AMENDMENT OF SOLICITATION/MODIFICATION OF CONTRACT

2. AMENDMENT/MODIFICATION NO. 0005
3. EFFECTIVE DATE 1 August 2003
4. REQUISITION/PURCHASE REQ. NO.
5. PROJECT NO. (If applicable)

CENTRAL AND SOUTHERN FLORIDA ECOSYSTEM, CRITICAL RESTORATION PROJECT, WESTERN C-11 BASIN, PHASE 2, SPILLWAY 381, BROWARD COUNTY, FLORIDA

Central and Southern Florida Ecosystem Critical Restoration Project, Western C-11 Basin, Phase 2 Spillway 381.

DRAWING NO.
10 / 3

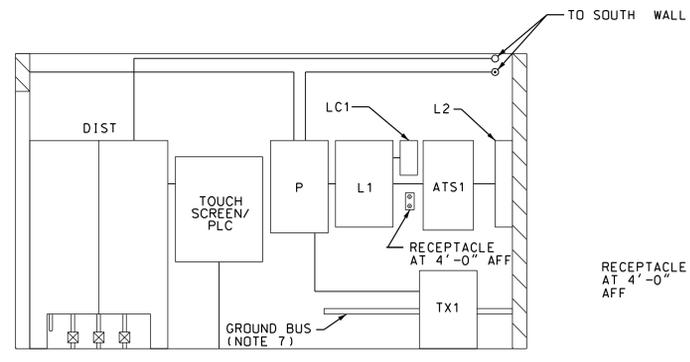
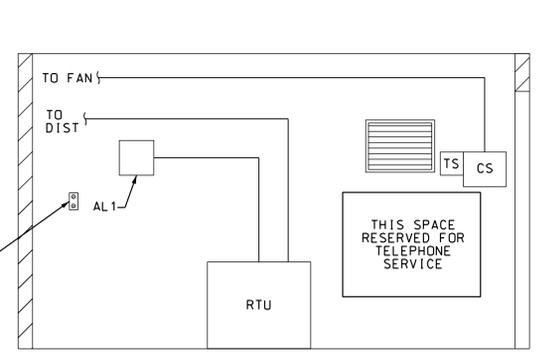
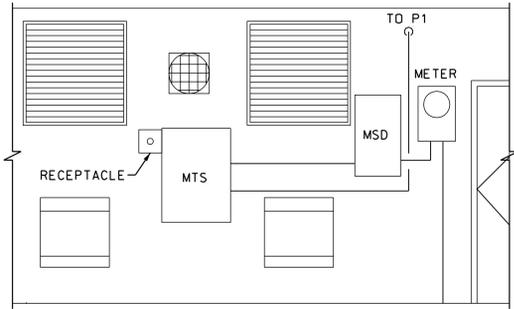
No.	Symbol	Zone	Description
2	△	IC-12	REVISED TO ACCOMPANY AMENDMENT NO. 0005
